AmerGen Energy Company, LLC
Three Mile Island Unit 1
Route 441 South, P.O. Box 480
Middletown, PA 17057

March 29, 2001
5928-01-20035

SUBJECT: THREE MILE ISLAND, UNIT 1 (TMI UNIT 1)
OPERATING LICENSE NO. DPR-50
DOCKET NO. 50-289
LICENSE AMENDMENT REQUEST NO. 308 –
PRESSURE TEMPERATURE OPERATING CURVES

Figure 3.1-1
Reactor Coolant System Heatup/Cooldown Limitations
[Applicable through 29 EFY]

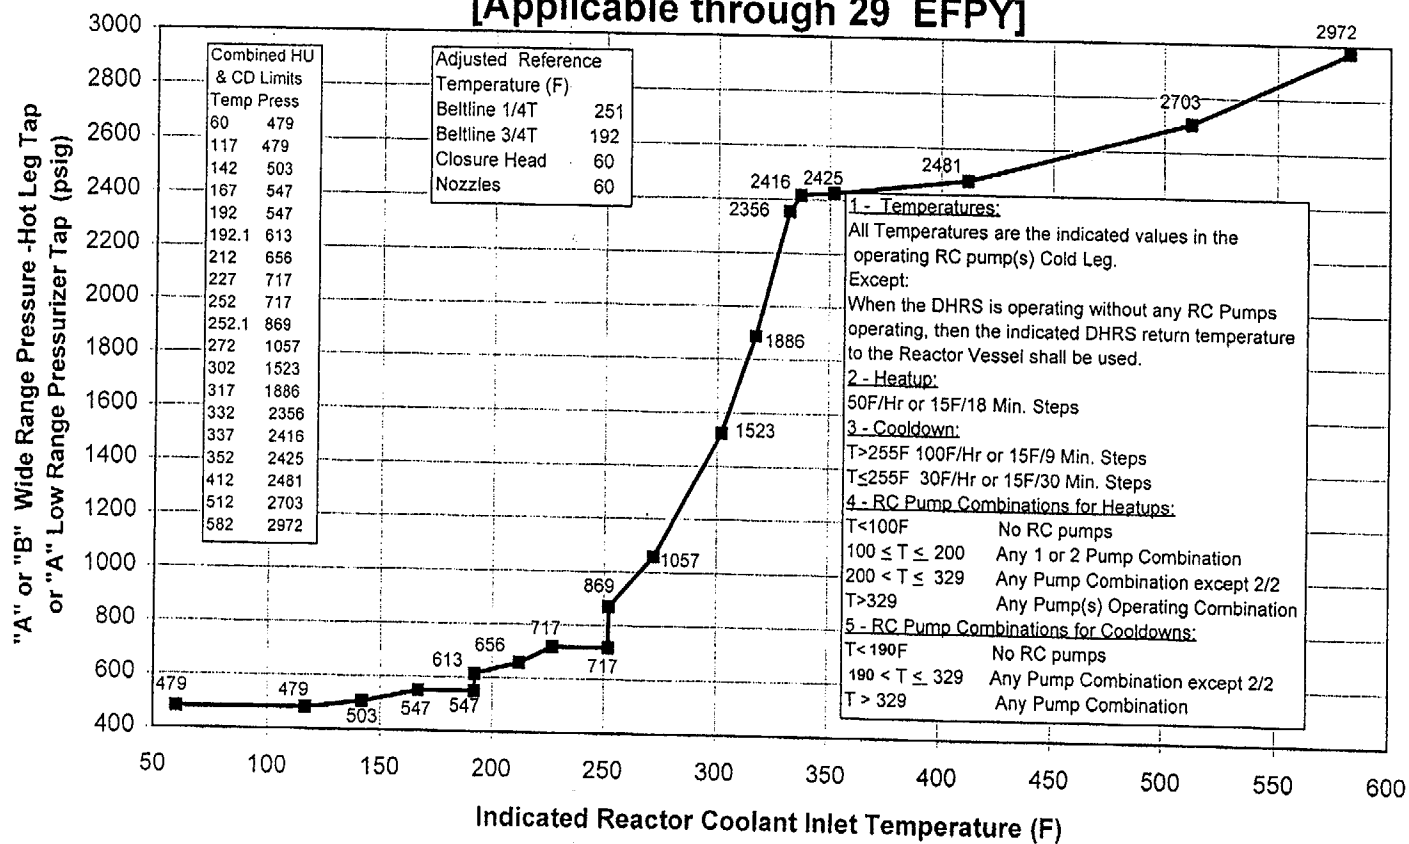
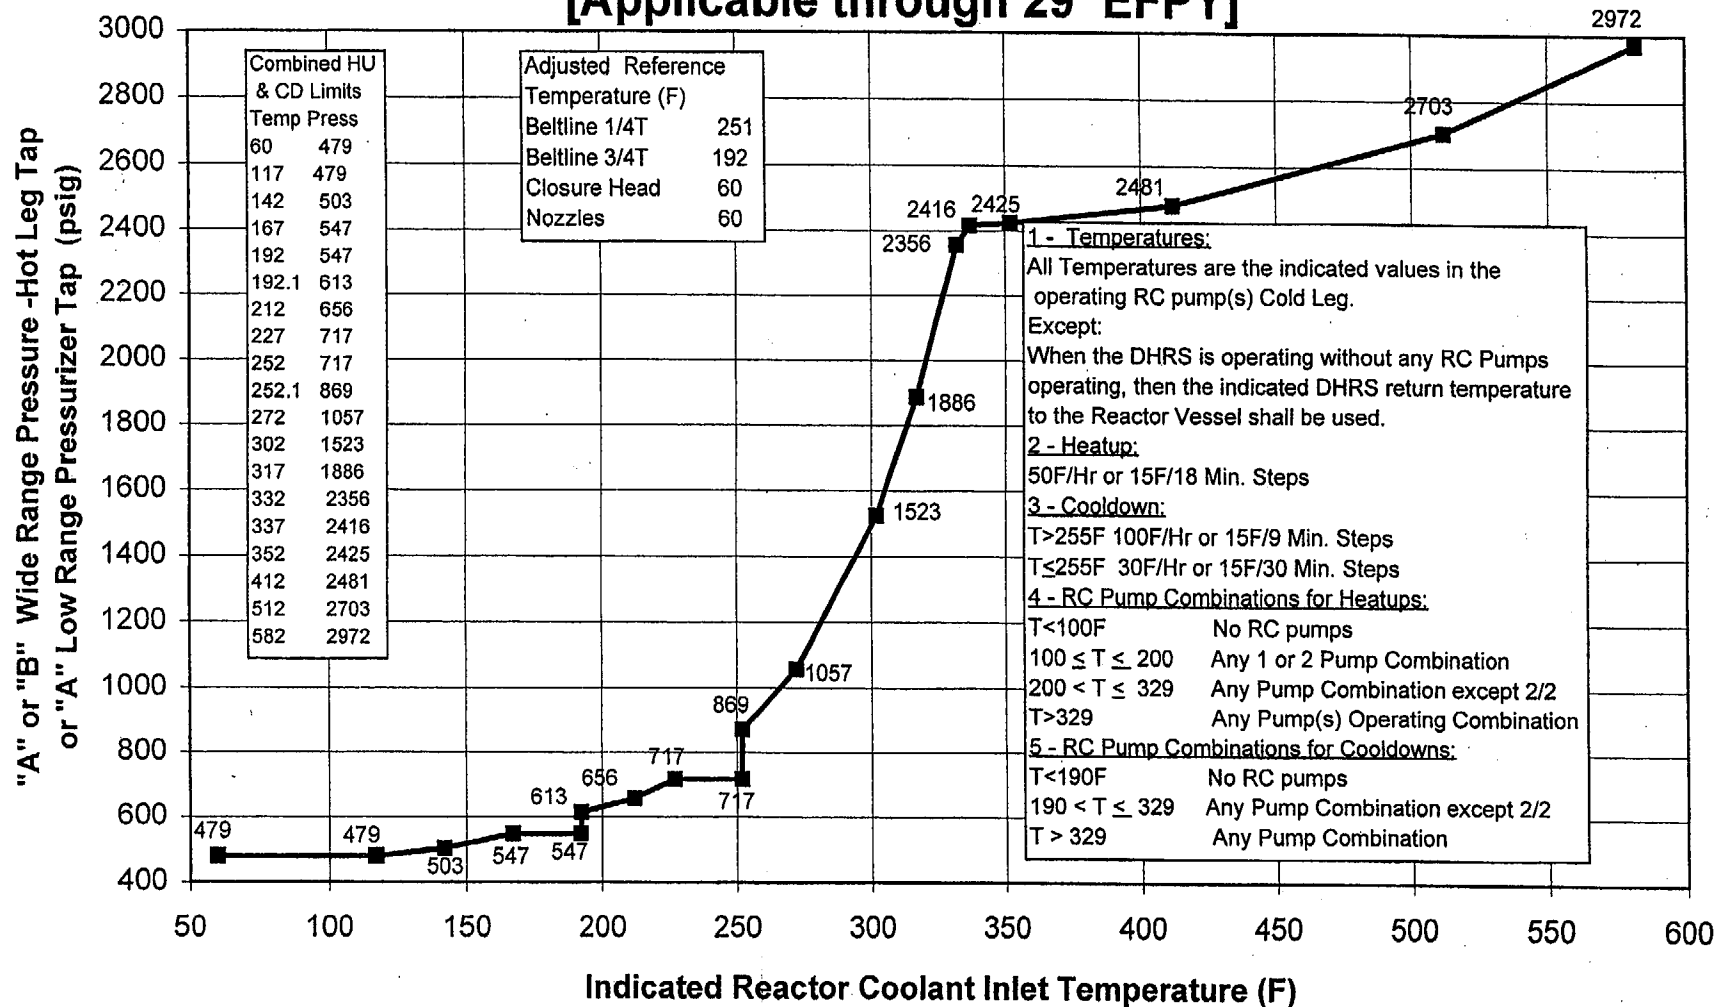
- 3.1.2.1 For operations until ²⁹~~17.7~~ effective full power years, the reactor coolant pressure and the system heatup and cooldown rates (with the exception of the pressurizer) shall be limited in accordance with Figure 3.1-1 and Figure 3.1-2 and are as follows:

Allowable combinations of pressure and temperature shall be to the right of and below the limit line in Figure 3.1-1. Heatup and cooldown rates shall not exceed those shown on Figure 3.1-1.

Based on the predicted RT_{NDT} after ~~17.7~~ effective full power years of operation, the pressure/temperature limits of Figure 3.1-1 and 3.1-2 have been established by FTI calculation, Reference No. 7, in accordance with the requirements of 10 CFR 50, Appendix G. Also, see Reference 4. The methods and criteria employed to establish the operating pressure and temperature limits are as described in BAW-10046A, Rev. 2. The protection against nonductile failure is provided by maintaining the coolant pressure below the upper limits of these pressure temperature limit curves.

Figure 3.1-2
Reactor Coolant Inservice Leak Hydrostatic Test
[Applicable through 29 EFPY]

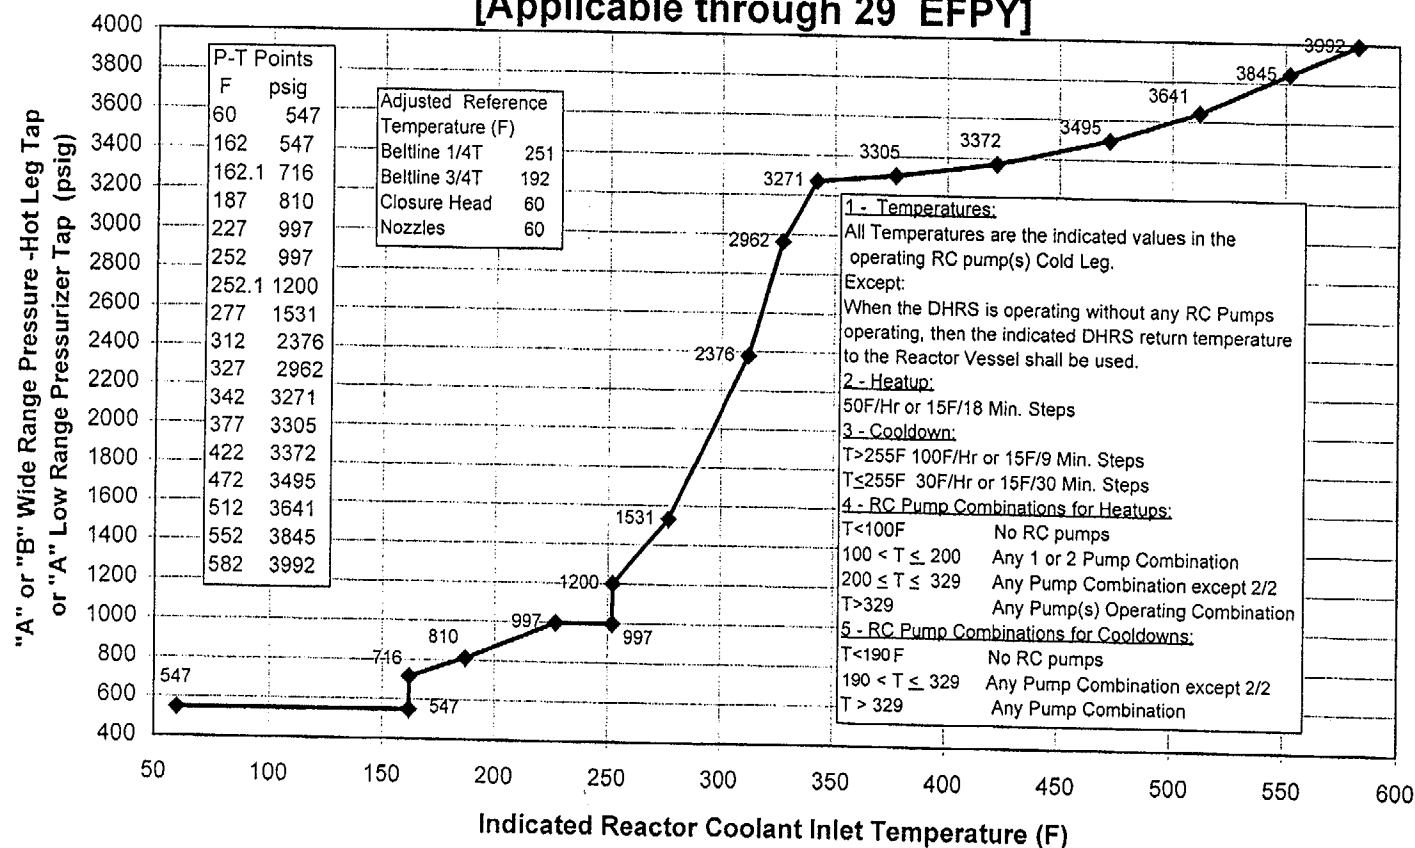
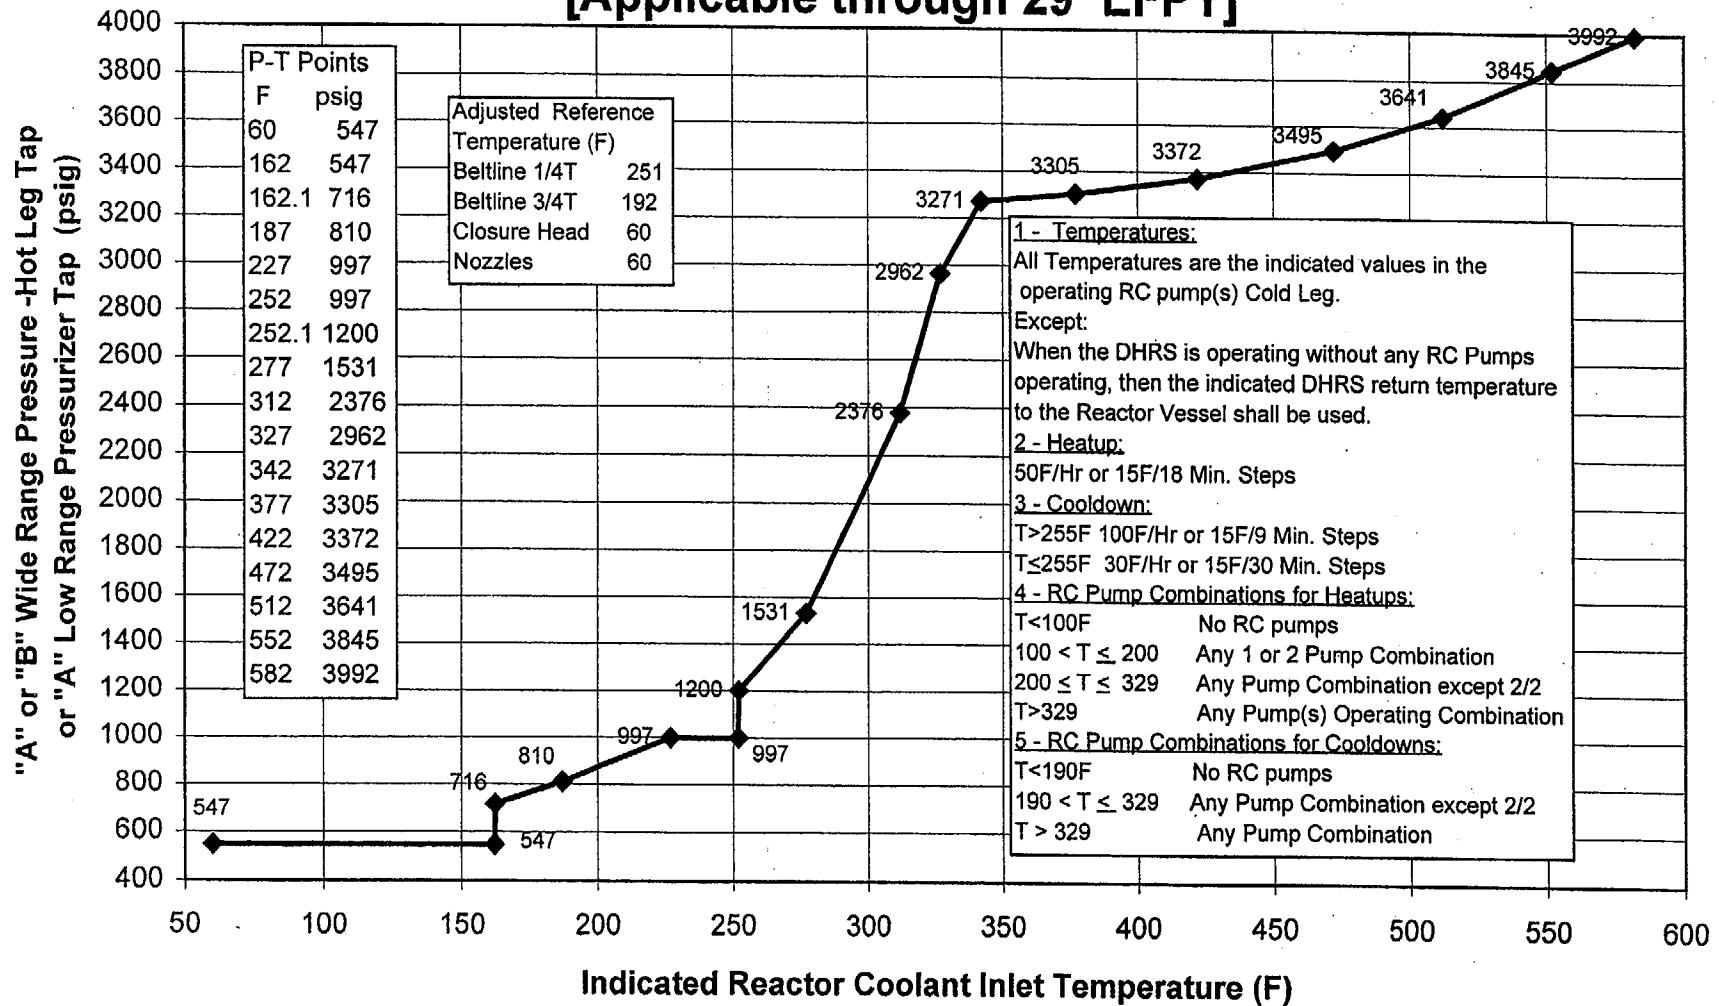
Allowable combinations of pressure and temperature shall be to the right of and below the limit line in Figure 3.1-2. Heatup and cooldown rates shall not exceed those shown on Figure 3.1-2.
